SUBJECT: UNITS 2/3 OFFSITE DOSE CALCULATION MANUAL Revision 24

Enclosed is Revision 24 to the Units 2/3 Offsite Dose Calculation Manual (ODCM). This revision added the component cooling water, storage tank area, and auxiliary building sumps as liquid release points and updated default flow rates from the common plant vent stack. Additionally, radiation monitor calibration constants were updated to reflect recent surveillances and there was one editorial change for typographical errors. None of the changes result in any modifications to either the plant configuration or operation. As such, there is no impact on the accuracy or reliability of methods for determining effluent dose or setpoint values.

OFFSITE DOSE CALCULATION MANUAL

NUCLEAR GENERATION SITE

FIGURE 4-5: SONGS 2&3 RADIOACTIVE LIQUID WASTE TREATMENT SYSTEMS

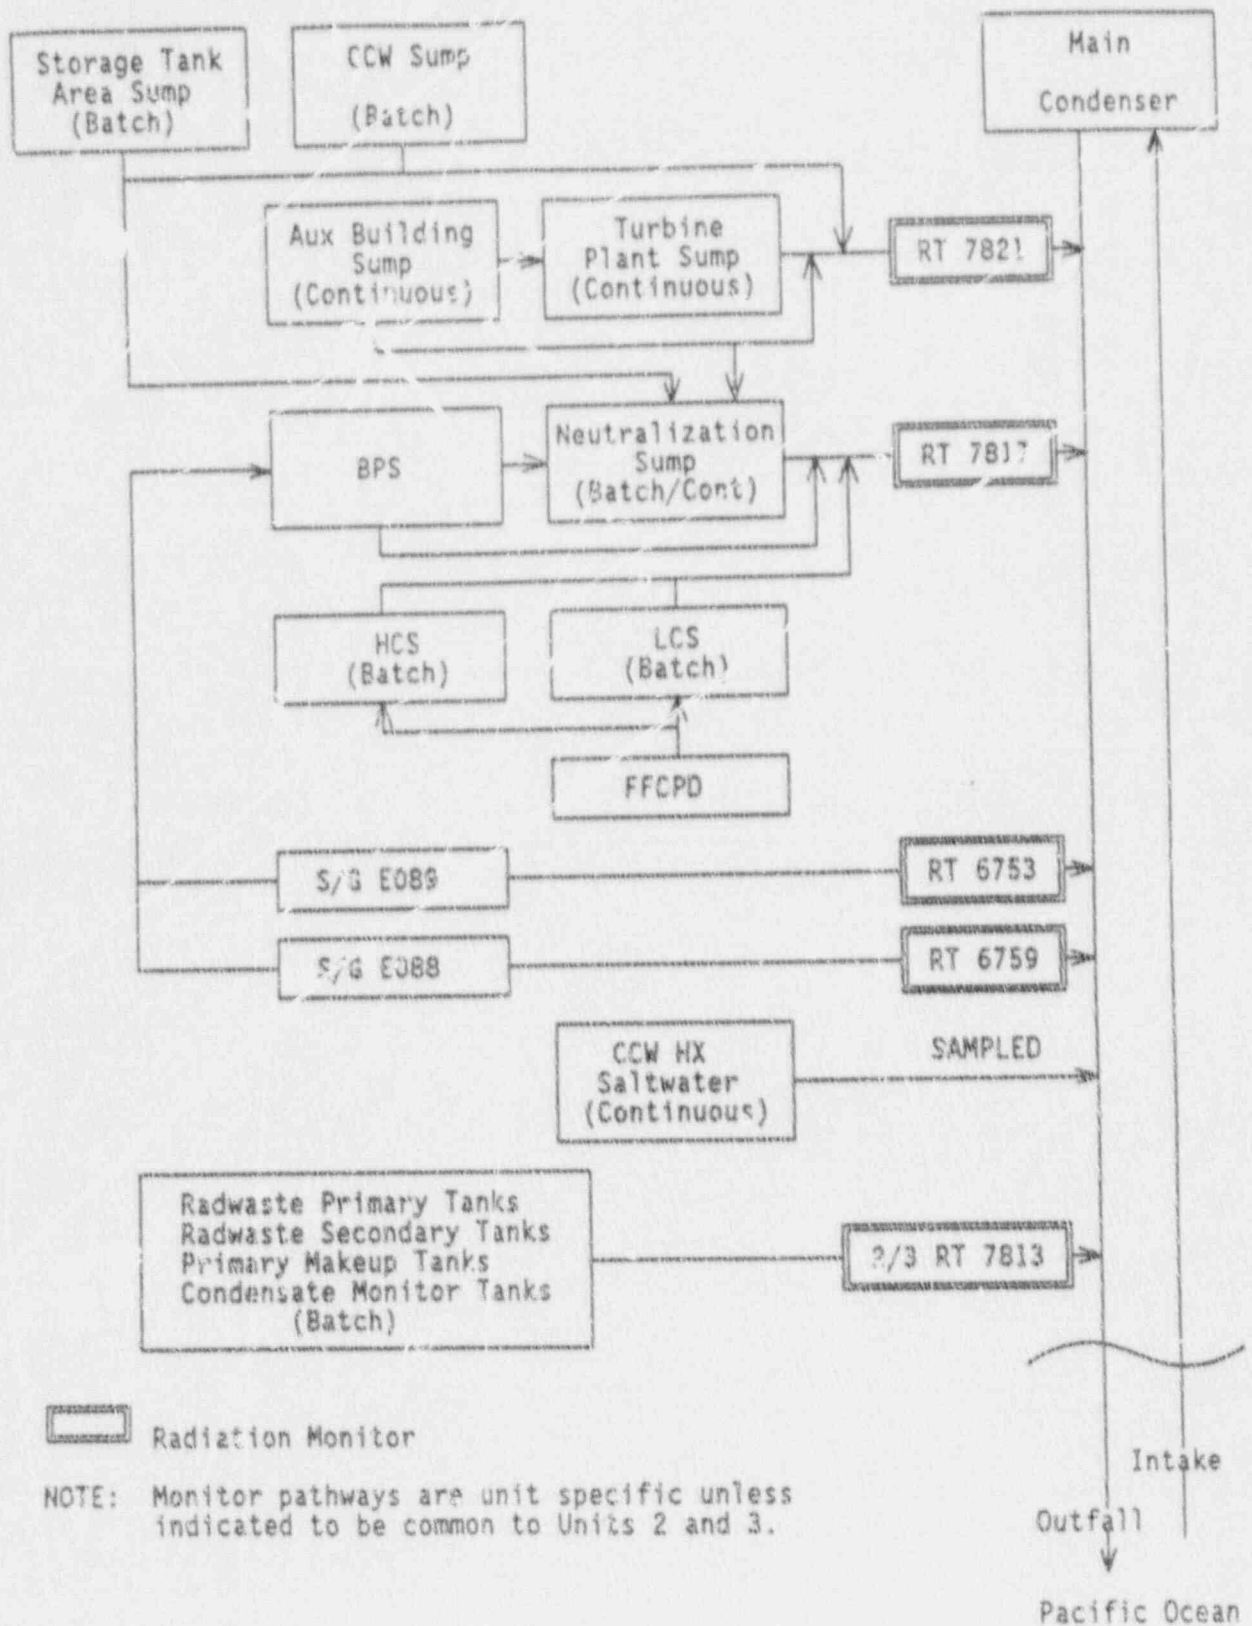
- 4-14 Figure 4-5 updated to reflect additional liquid release points.
